Planning Commission MEETING AGENDA

Thursday, November 17, 2022 - 1:00 PM
Council Chambers, Easton Town Office
14 S Harrison Street

**PLANNING COMMISSION
PUBLIC HEARING
STAFF REPORT**

SUBJECT: Sketch Site Plan Review for 521 August Street (41 N. Park Street – Pending New Address)

SHEET NO.:
C-403.01

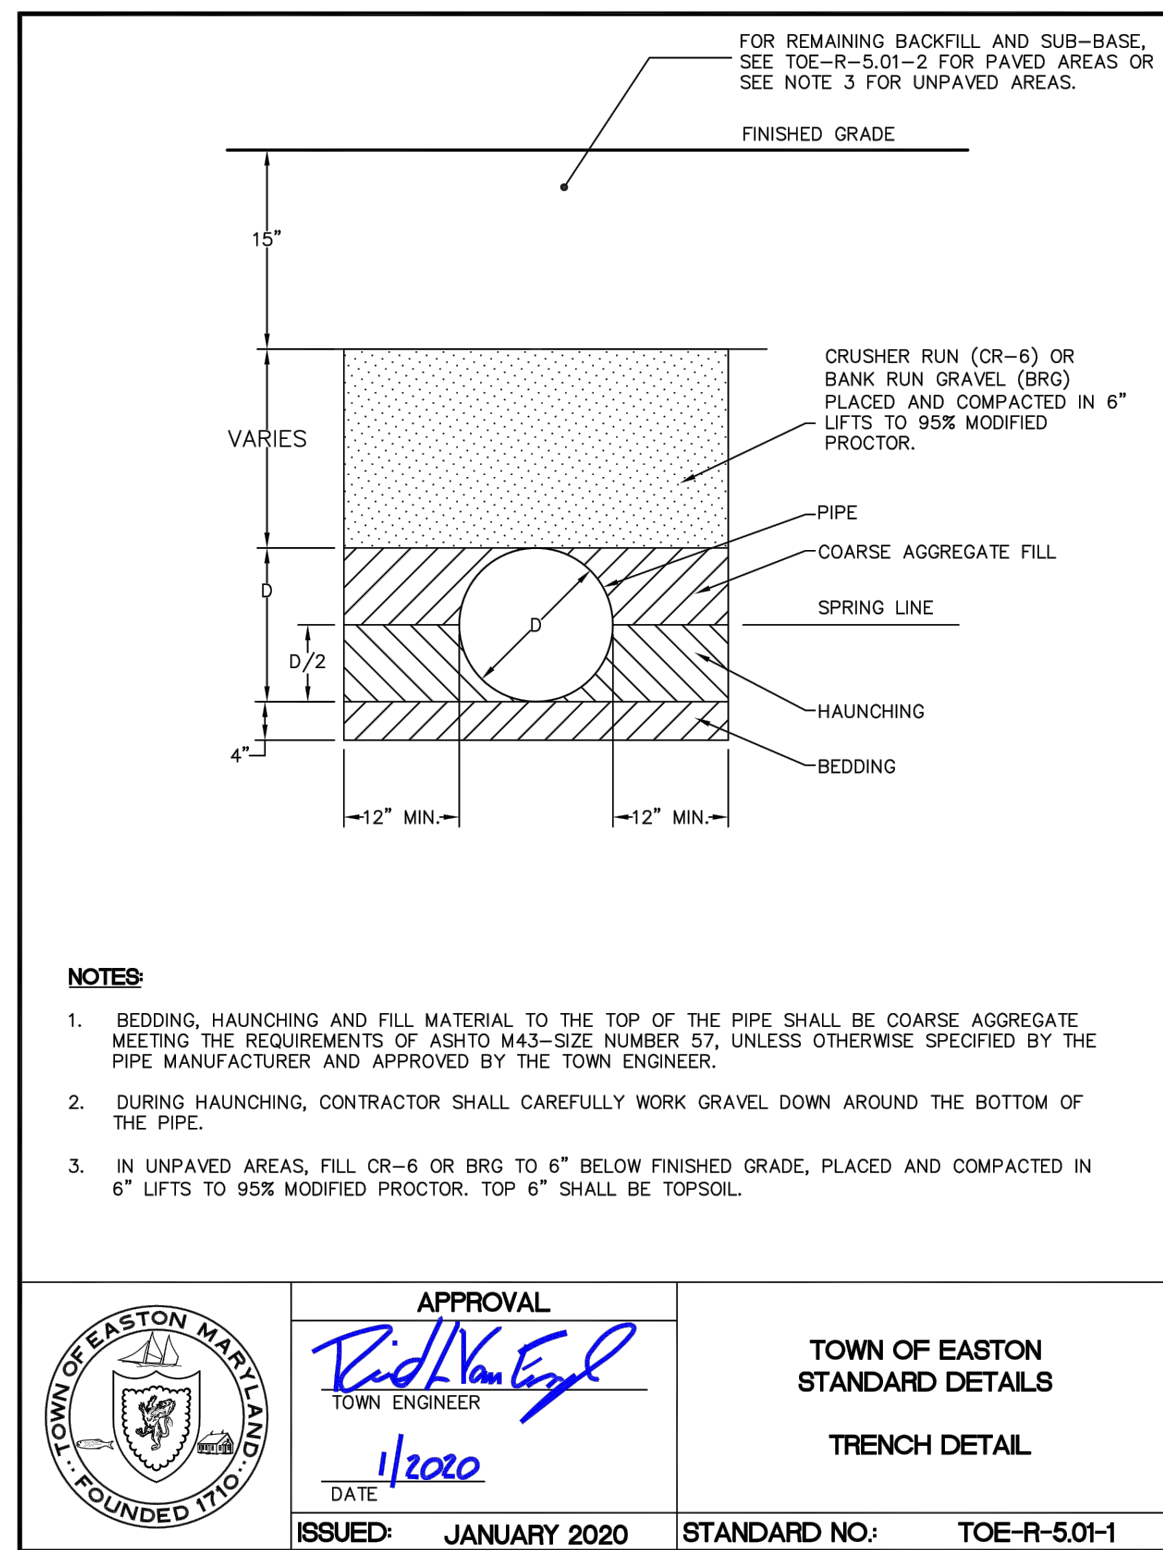
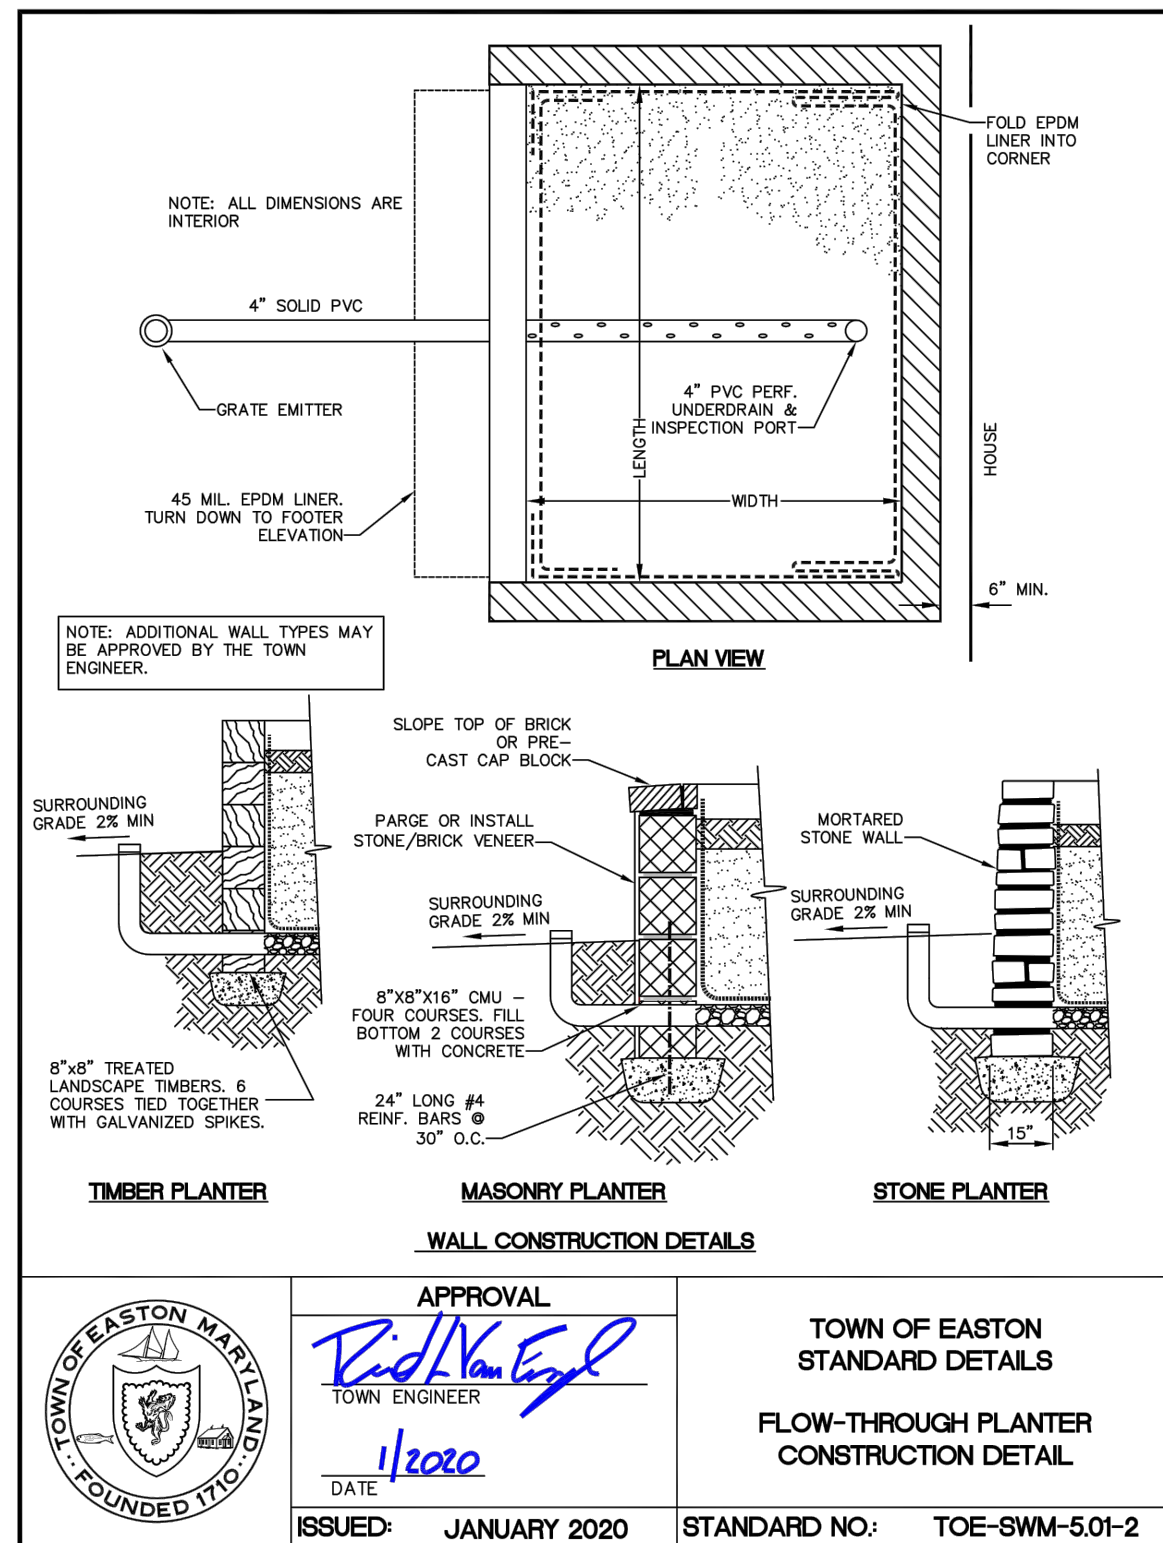
6. **SHEET C-403.01 - Section A Station 1+26±** - The proposed stormdrain pipe immediately downstream of the Rain Tank appears to be at an elevation higher than the Rain Tank. Please revise.
7. **SHEET C-403.01 - Section A Station 2+35±** - Show the existing gas main.
8. **SHEET C-403.01 - Sections B & C** - Show the proposed Planter Boxes.

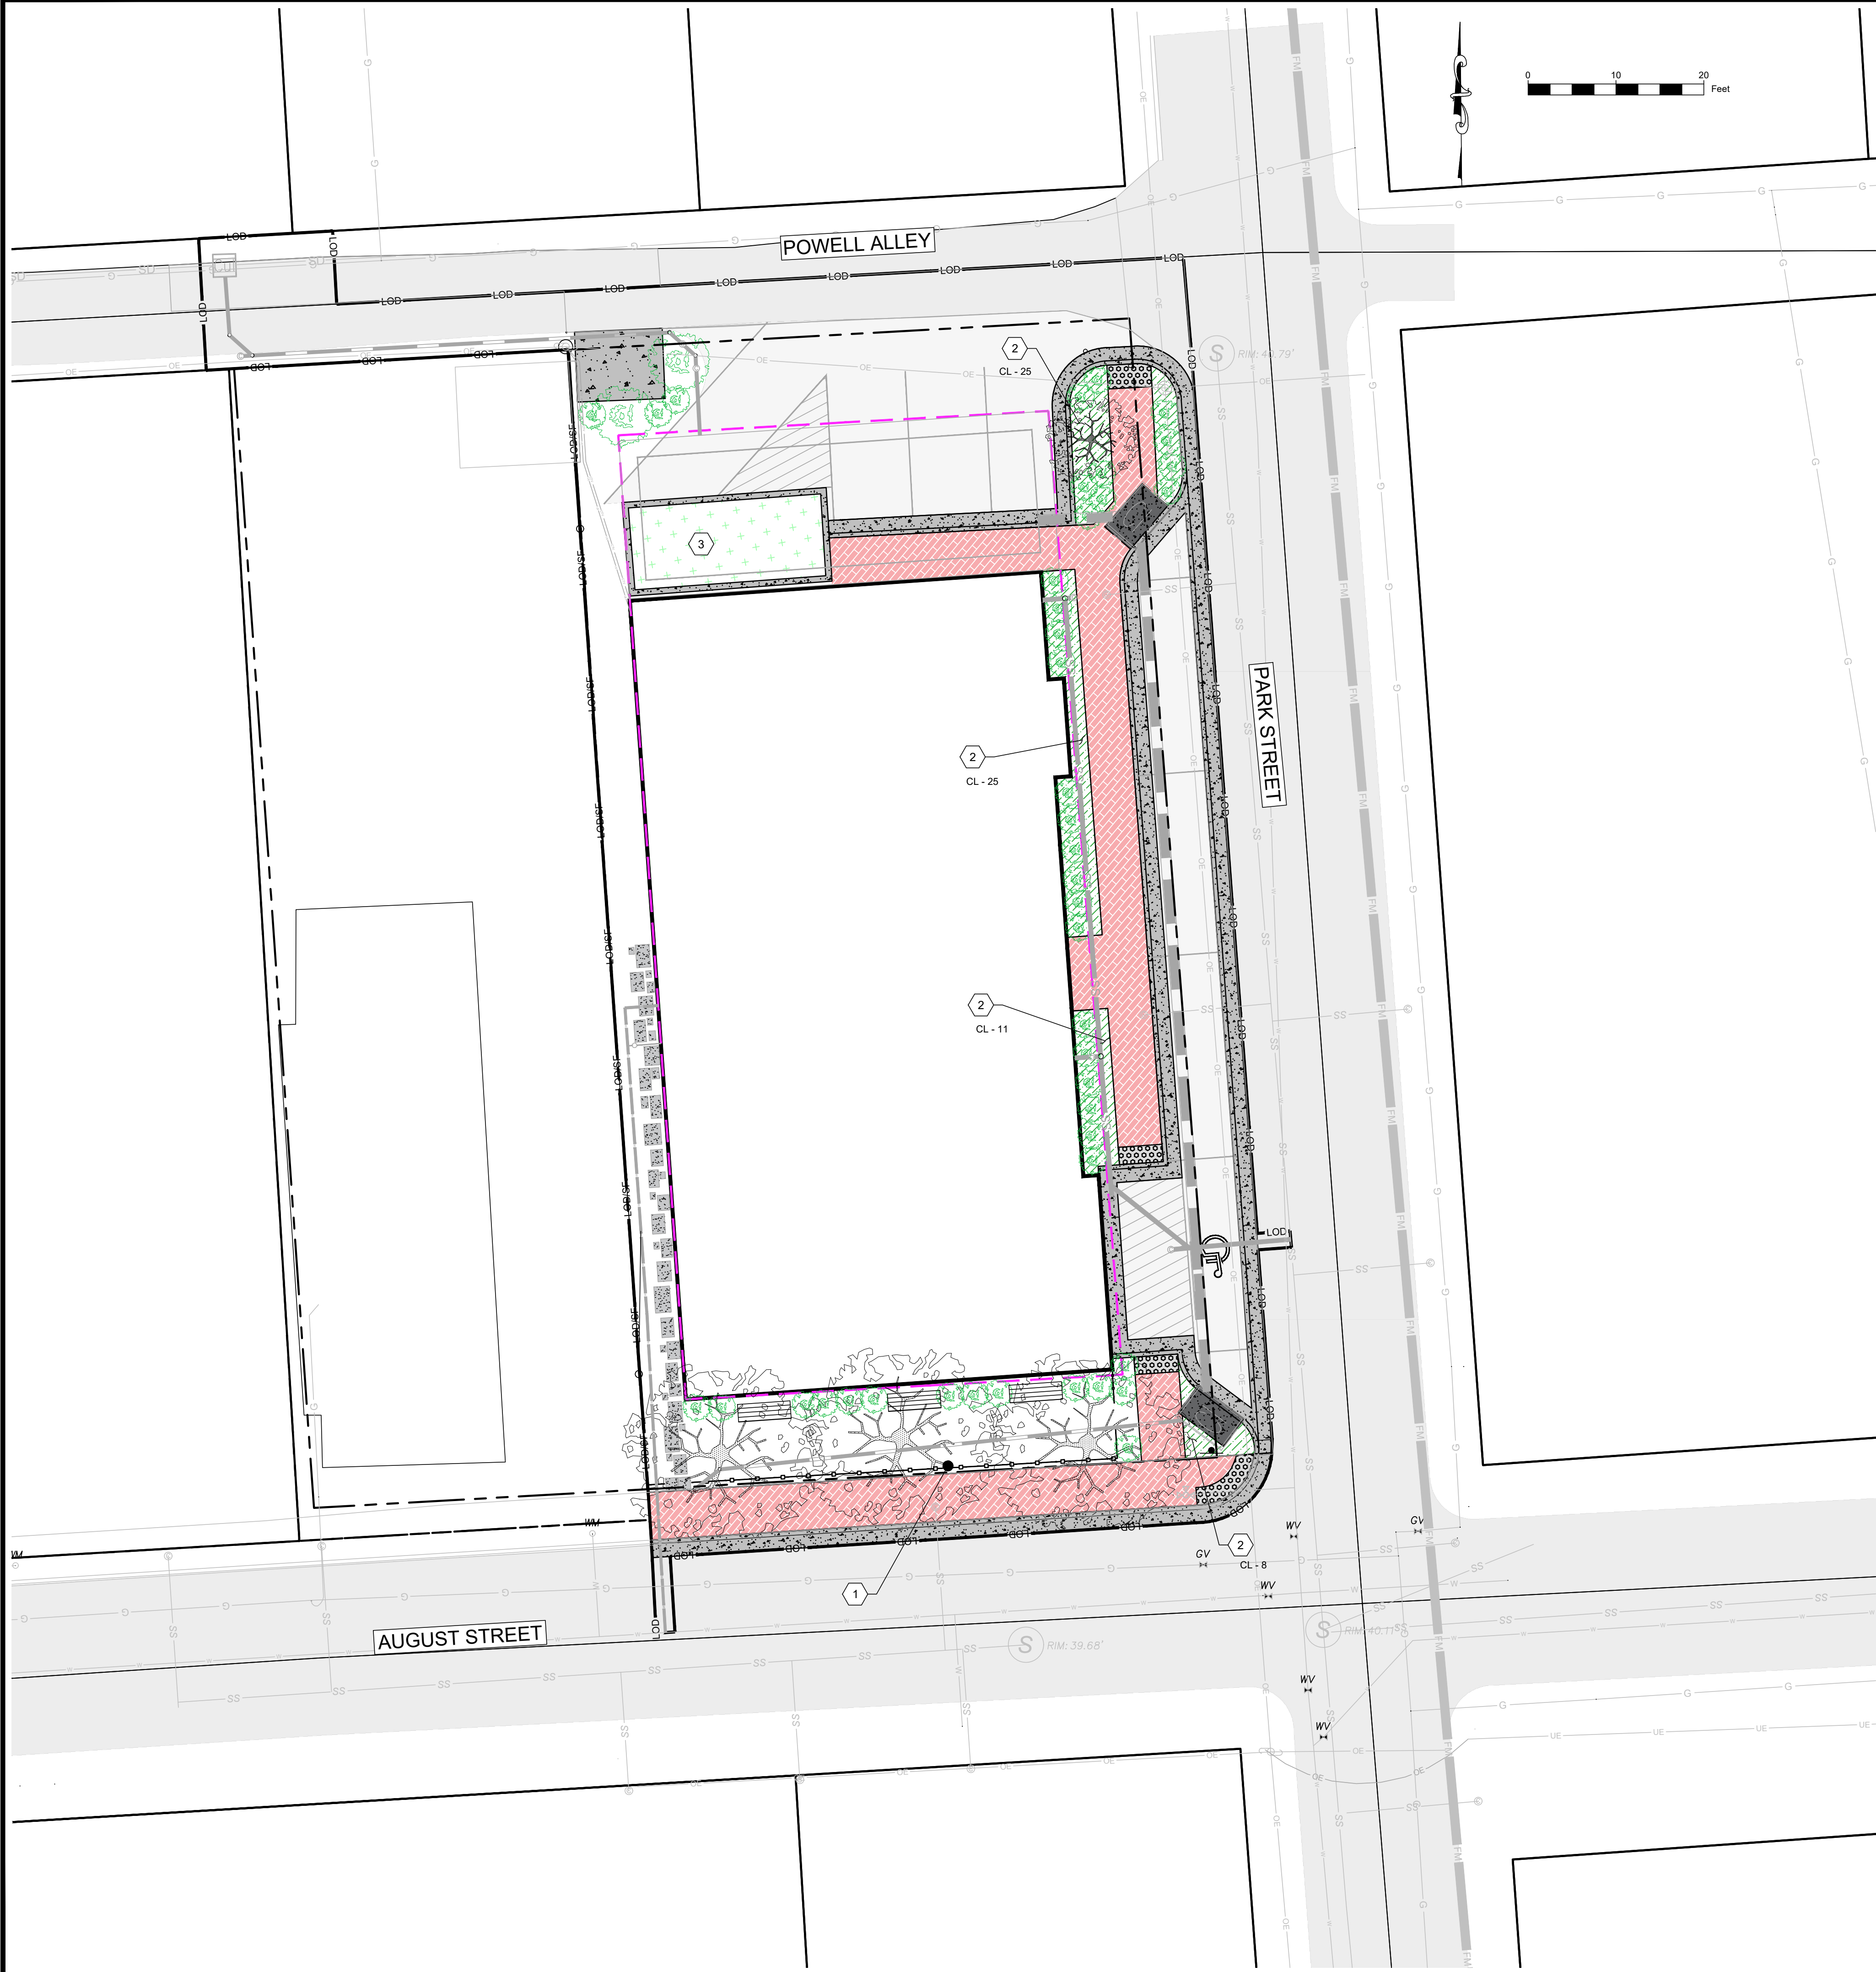
1. **SHEET C-601** - Provide a Landscaping Plan.
